RAI Volume 3, Chapter 2.2.1.2.1, Sixth Set, Number 5:

Figure 1. Comparison of Stress-Strain Curves Measured in the Laboratory on a Lithophysal Sample and Obtained by Voronoi Block Model Calibration

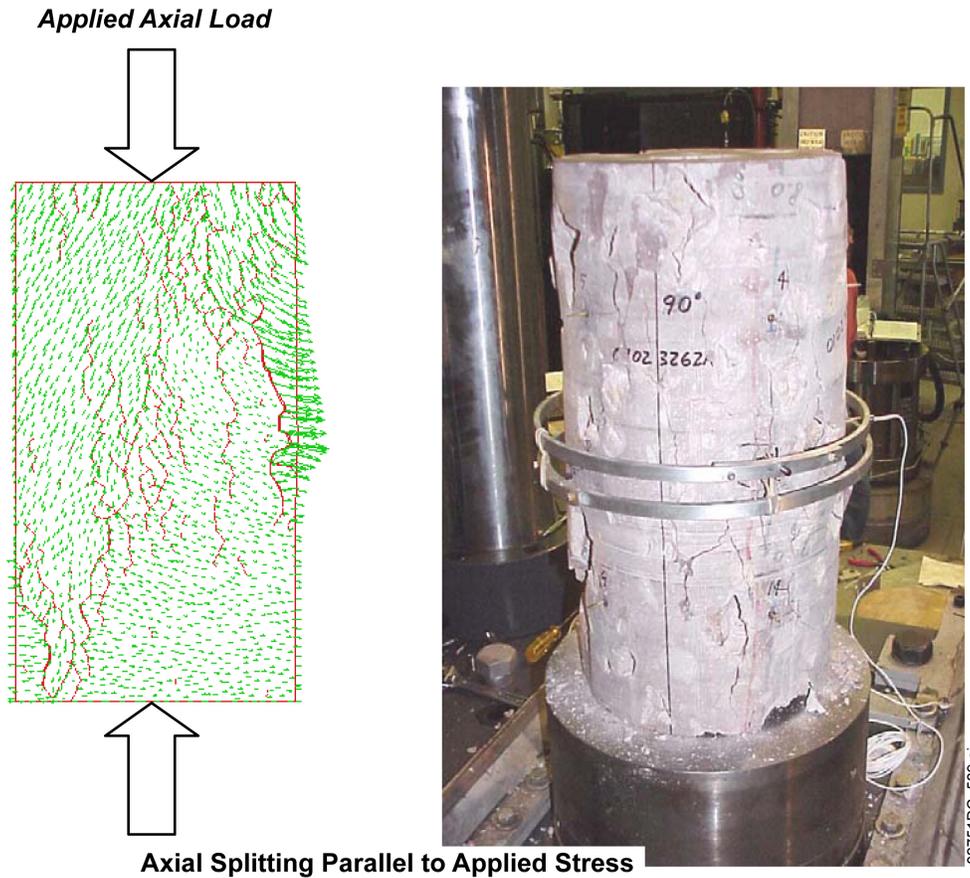
Provide an explanation of how rock blocks at the drift interface maintain cohesion after failure when the modeled stress-strain curve (DOE, 2009, RAI-3, Figure 1-4) indicates a brittle mode of rock failure should occur. Additionally, clarify how blocks in the UDEC-Voronoi model remain in place if the supporting contacts between the blocks have failed.

Basis: DOE concluded the UDEC-Voronoi model shows a more brittle response compared to the stress-strain test on Topopah Spring lower lithophysal tuff (DOE, 2009, RAI-3 and RAI-5). Additionally, the modeled post-peak curves presented in BSC (2004, section 7.6.4) are nearly vertical, and represent a near-brittle mode of deformation (e.g., Jaeger and Cook, 1979). Thus, the near-vertical slope of the post-peak portion of the modeled stress-strain curves suggests that, after failure, the remaining rock strength should be negligible, consistent with a brittle failure mechanism. Additionally, in DOE (2009, RAI-1, Figure 1-3), the UDEC model appears to allow some blocks at the drift wall to remain in place after the supporting contacts between the blocks have failed. This result appears inconsistent with the modeling approach, in which blocks supported by failed contacts should fall from the drift wall.

Even in the post-peak state, Figure 1 demonstrates that the rock within the synthetic model has not completely disintegrated after formation of discrete macro fractures. Although stress can decrease to 50% of the peak stress in the post-fracture state, as shown by the end of the blue line in Figure 1, the material is not perfectly brittle because the post-peak slope of the blue stress-strain curve remains finite. This behavior is consistent with Figure 2, which compares the geometry and cracking of the UDEC Voronoi block model with a test core at the end of an unconfined compression test. Figure 2 shows that, at the end of testing, there is still a large volume of rock that is unfractured for both the Voronoi block model and for the test core. Although Figures 1 and 2 show that the macroscopic response of the core after failure is softening in a brittle manner and losing a significant portion of its apparent (macroscopic) cohesion, large volumes of rock internally maintain their intact cohesion. The term “softening” describes degradation of strength as a function of deformation after the peak-strength of material has been reached (BSC 2004, Section 7.4.1).

The post-failure response of the Voronoi block model is not perfectly brittle because of the presence of unfractured rock mass and because of the frictional resistance to slippage in the failed contacts and macro fracture(s). These features produce a finite softening rate and some residual strength after failure of the core, as shown by the finite slope of the blue curve in Figure 1 after peak stress. Stated differently, the UDEC Voronoi block model under unconfined compression has some small but finite ductility. At any point of the stress-strain curve, even on the softening part, it is necessary to provide additional energy to continue deformation of the sample.
